AIA® Document G710™ – 2017

Architect's Supplemental Instructions

PROJECT: *(name and address)*
17-13 OSU College of Med. at Hastings
Tahlequah, OK

ASI INFORMATION:
ASI Number: Bid Pack 03-ASI 04
Date: 08/08/19

SHEET NUMBER:
S4.02

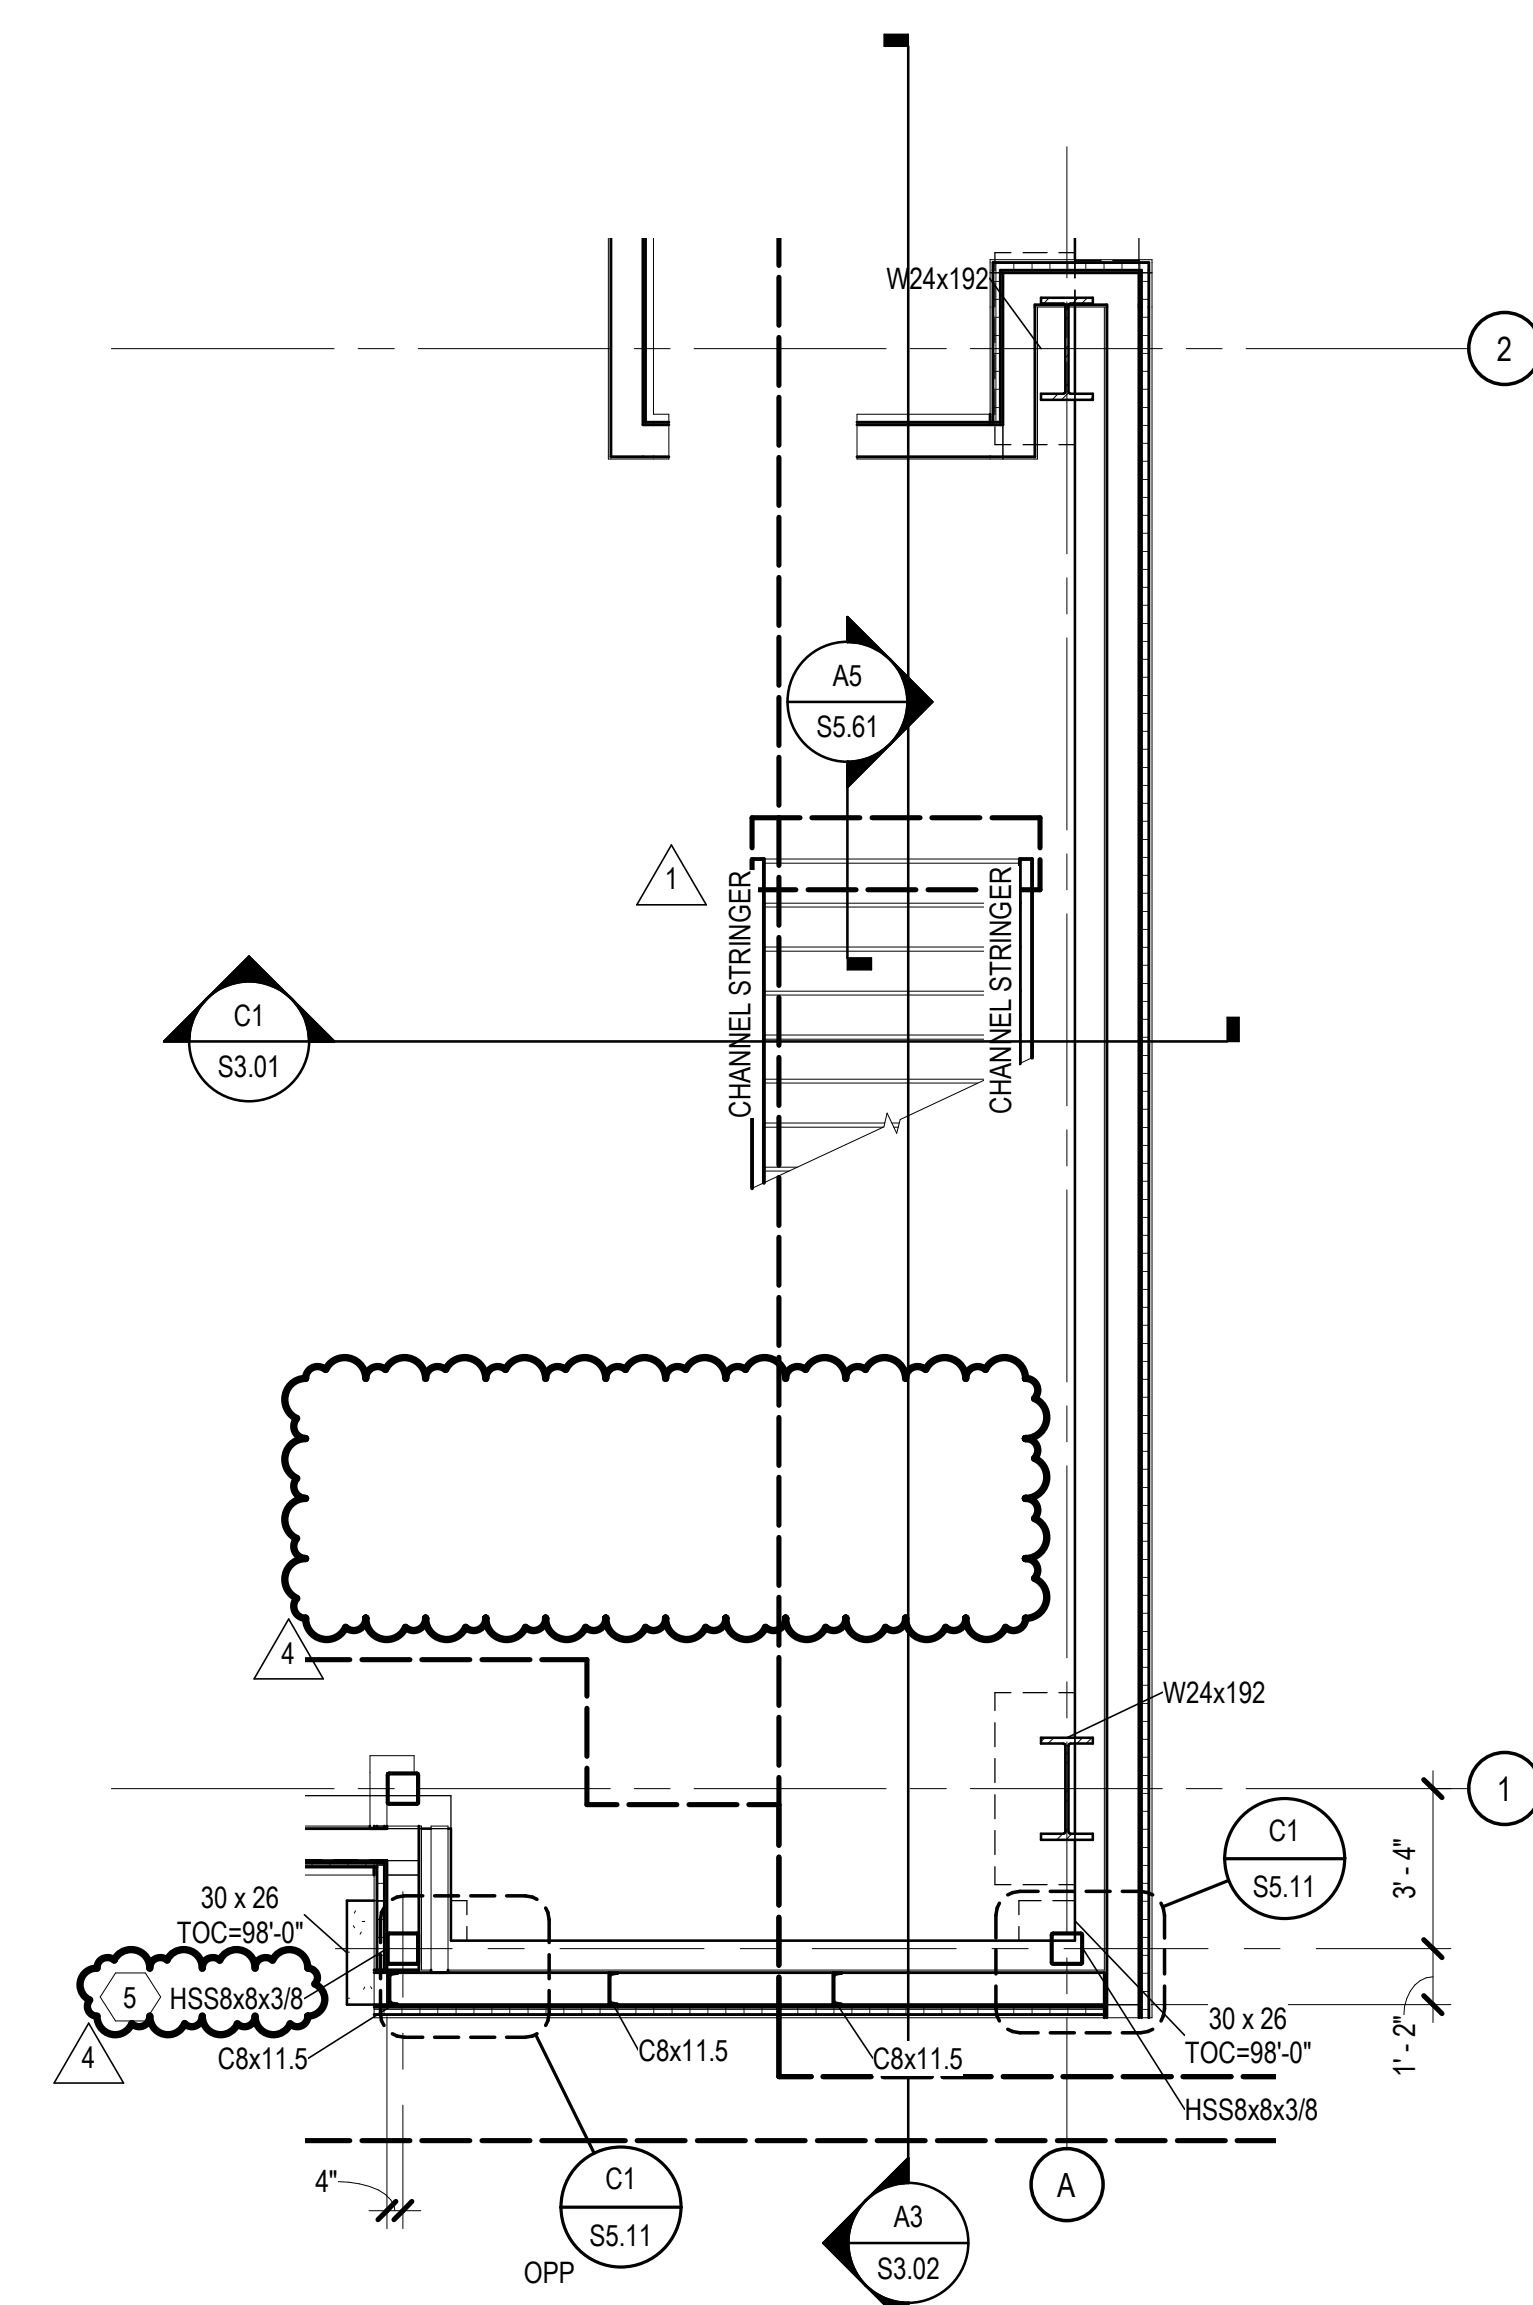
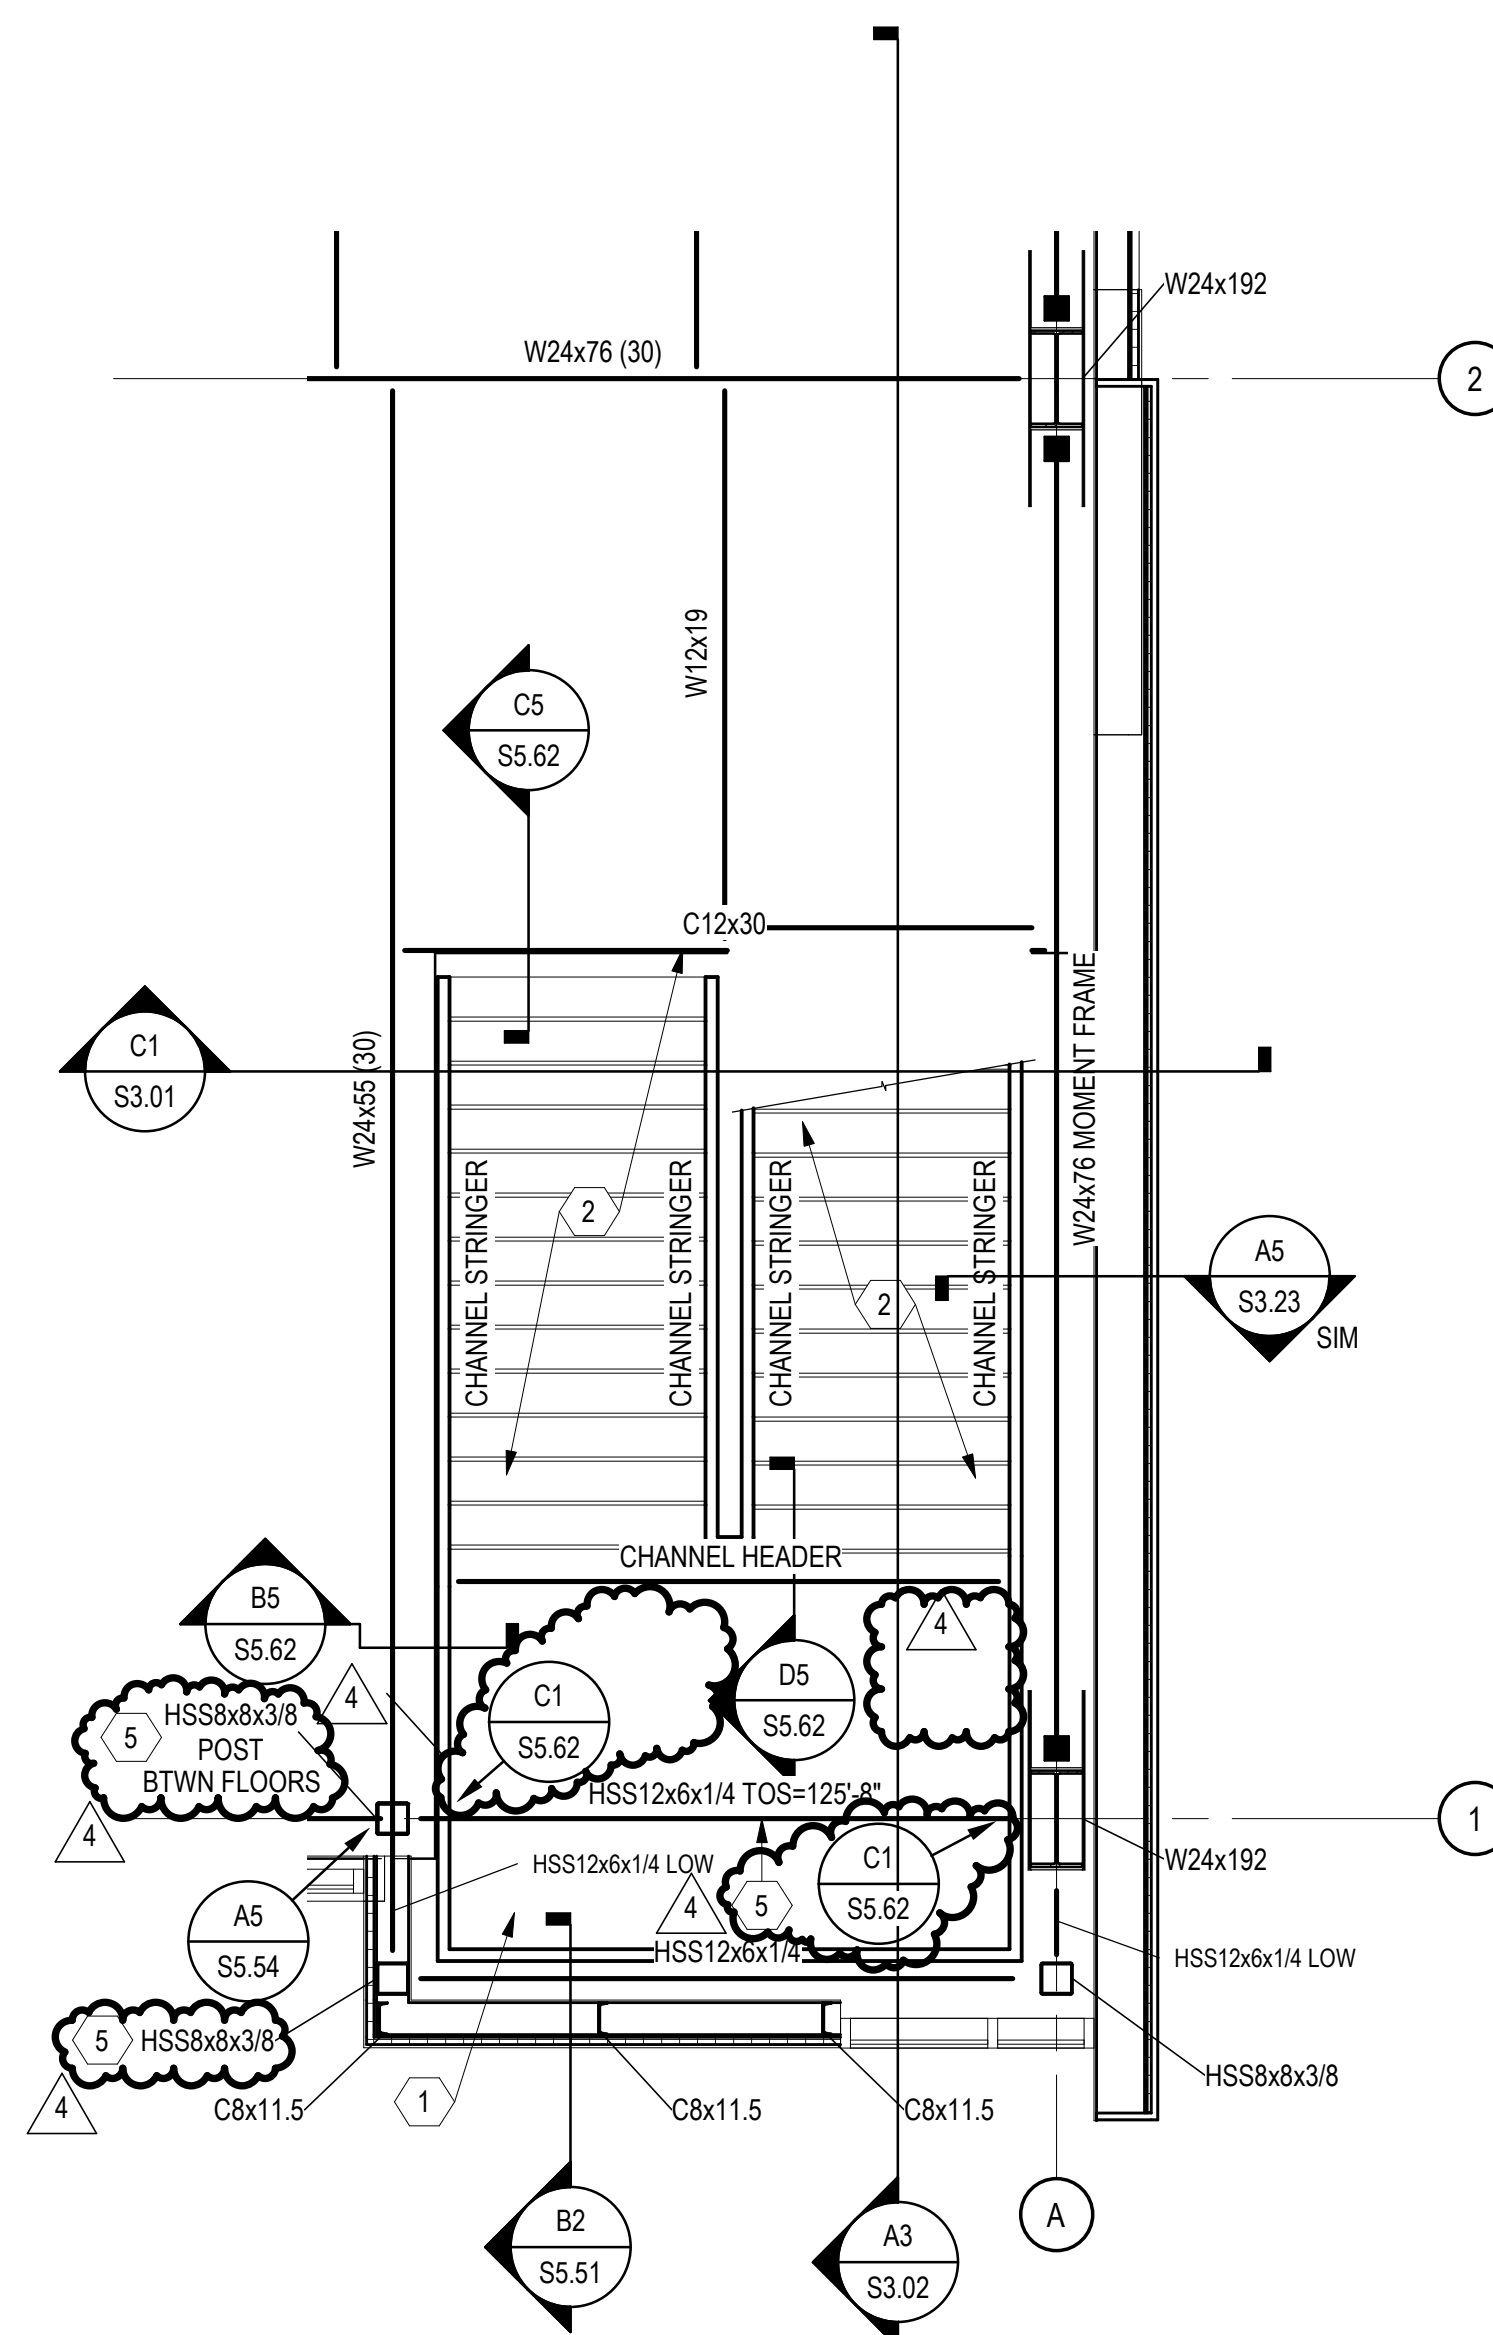
<u>Sheet</u>	<u>Description</u>
S2.02	Braced frame elevations A1, B1, C1, D1, D2, D3, D4, and D5 updated to include additional connection information.
S3.02	Elevation A3 top of steel elevations updated at stair landings.
S4.01	Plan A2 updated to contain revised information for elevated stair landing at the roof level.
S4.01	Plans B3, C3, and D3 updated to contain clarifying hanger connection information.
S4.02	Sheet keynotes 3, 4, and 5 added. Keynotes added on plan.
S4.02	Beam added at landing on plan C4.
S4.02	Stair posts and spread footings removed on plan A4.
S4.02	Stair posts removed from plans A3 and C4.
